#### **23. TESTON SANDS INC. ZONING BY-LAW AMENDMENT FILE Z.21.046 DRAFT PLAN OF SUBDIVISION FILE 19T-17V009 - 1600 TESTON ROAD VICINITY OF DUFFERIN STREET AND TESTON ROAD**

**DRAFT PLAN OF SUBDIVISION FILE 19T-17V009**

To seek approval from the Committee of the Whole for Zoning By-law Amendment and Draft Plan of Subdivision Files Z.21.046 and 19T-17V009. The Owner seeks to rezone portions of the subject lands as shown on Attachment 2 to permit revisions to the previously approved 90 lot draft plan of subdivision, and to request additional zoning exceptions for building height, setbacks and encroachments, and to revise the stormwater management regime from a pond to underground storage tank which necessitates revisions to the approved zoning by-law and conditions of Draft Plan of Subdivision File 19T-17V009, as shown on Attachment 3.

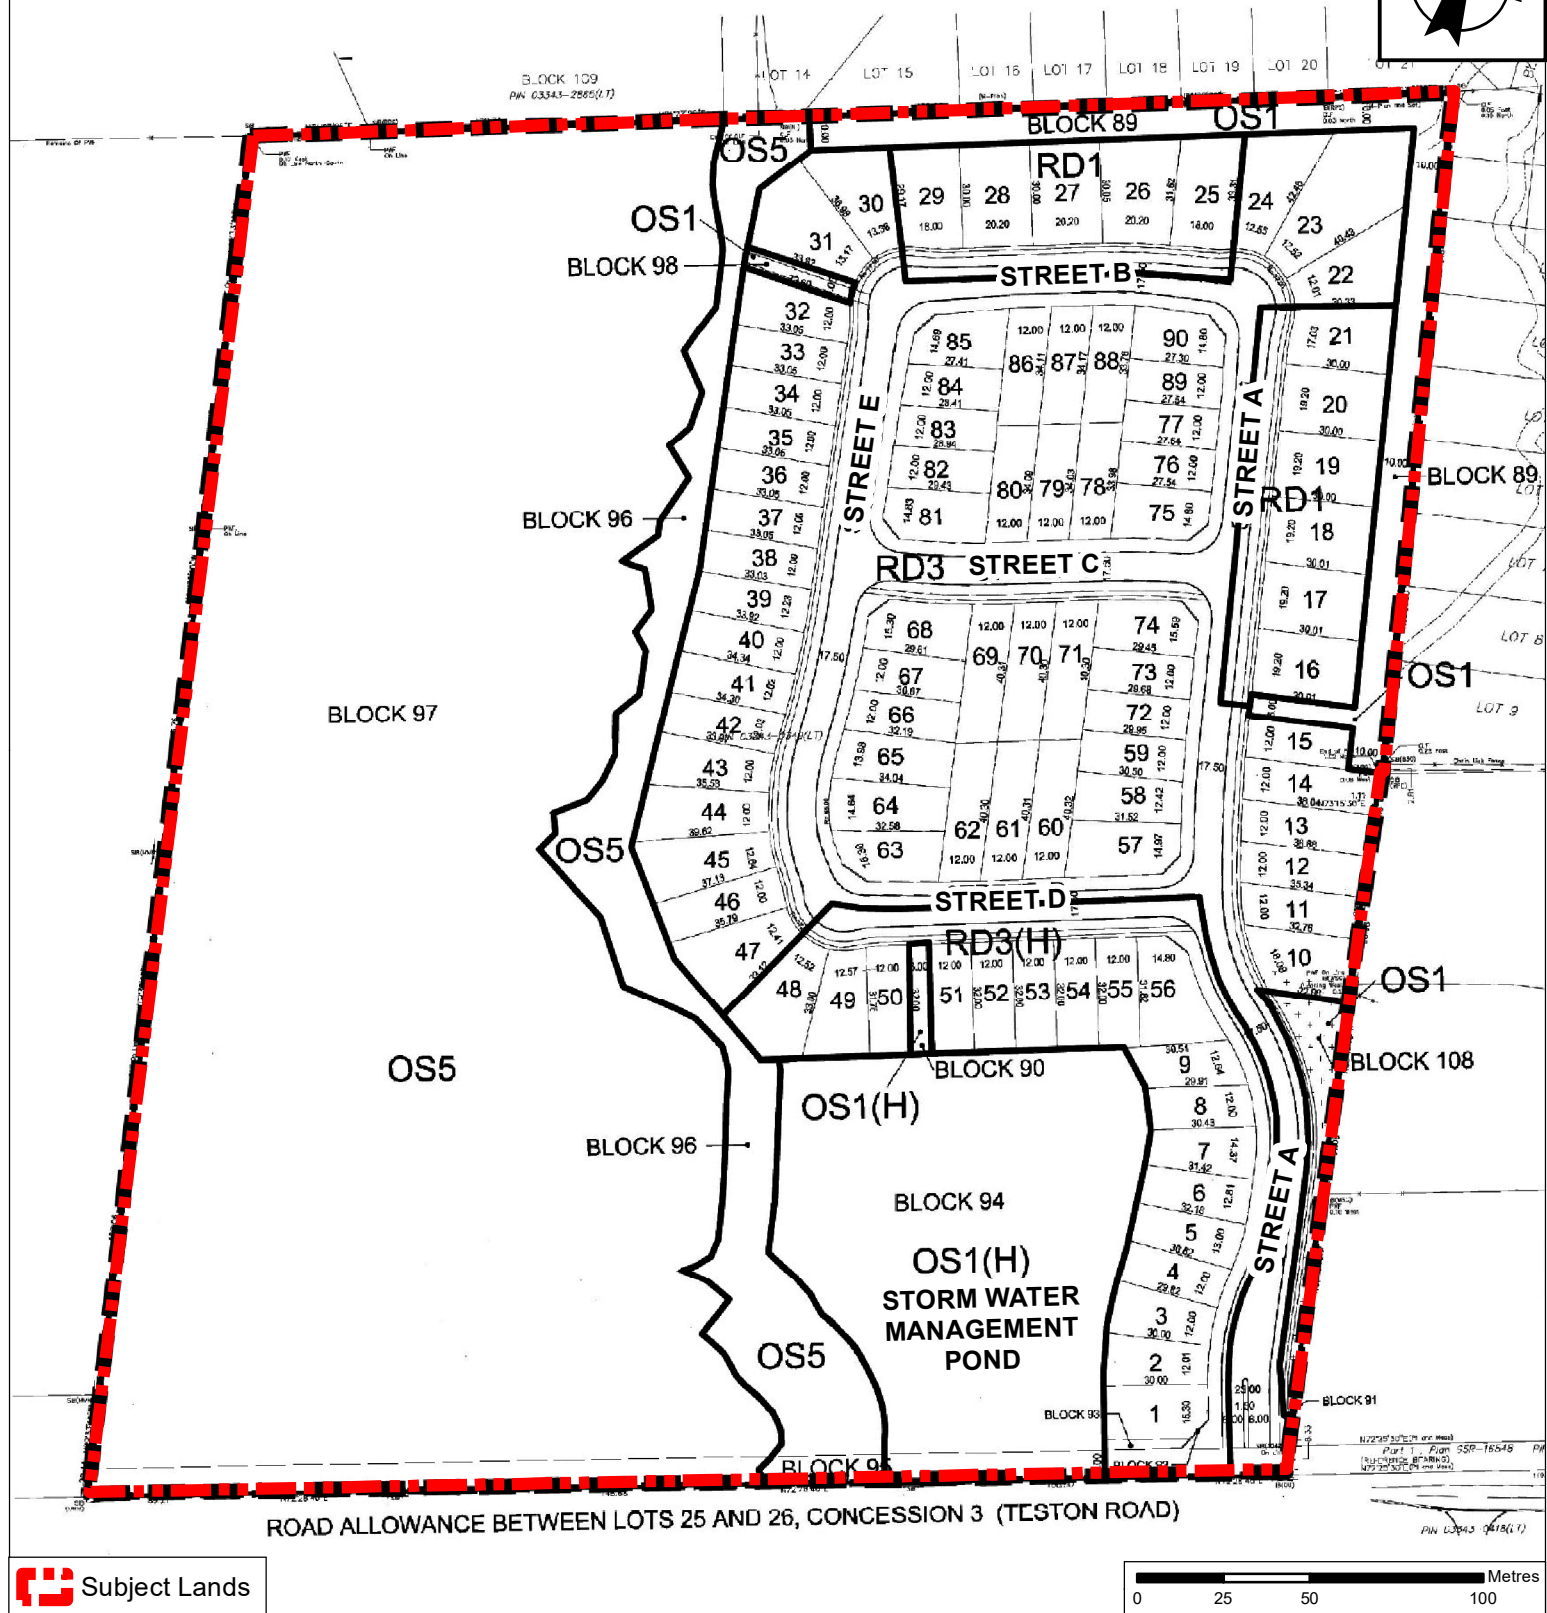
Revised Subdivision Design - Redlined Plan

The Draft Plan shown on Attachment 3, does not differ significantly from the Draft Plan approved by the OLT as shown on Attachment 5. The revised draft plan of subdivision consists of 90 residential lots for dwelling units with frontages ranging from 12 m to 20 m, with lot depths ranging from 27 m to 50 m and it facilitates a Draft Plan of Subdivision in accordance with the City's design standards. The Street "A" alignment shifted slightly east where it intersects with Teston Road and will be 23 m wide at the intersection and taper to 17.5 m internal to the Draft Plan which is consistent with the width of the other public roads within the Draft Plan shown on Attachment 3. The proposed lots, blocks and public roads are generally consistent with the lot pattern and road network shown on Attachment 5 OLT Approved Draft Plan of Subdivision File 19T-17V009 and OLT Approved Zoning.

The Landscape Plan shall be revised to correspond to the revised Draft Plan (Attachment 3) and the north-south line located between the access portion of Block 91 from Street "A" and the 10 m wide buffer section of Block 91 shall be red-lined to remove it from the Plan. The title Block on the revised Draft Plan shall be revised to remove Block 91 as a Walkway. The reference to "Block 91 as a walkway" was part of

The proposed underground SWM storage tank is located in Block 93 and requires an outlet to drain to the existing natural pond located to the west of Block 96. The outlet shall be identified on the Red-lined Draft Plan of Subdivision and shall be dedicated to the City of Vaughan, to facilitate ongoing maintenance and operation of the underground SWM storage tank. The location of the block required for the outlet is shown on Attachment 3 labeled as Block X. The Draft Plan shall be revised to address the location for the outlet within "Block X". This Block shall be conveyed to the City to provide for access and maintenance in conjunction with the proper function of the underground SWM storage tank on Block 93.
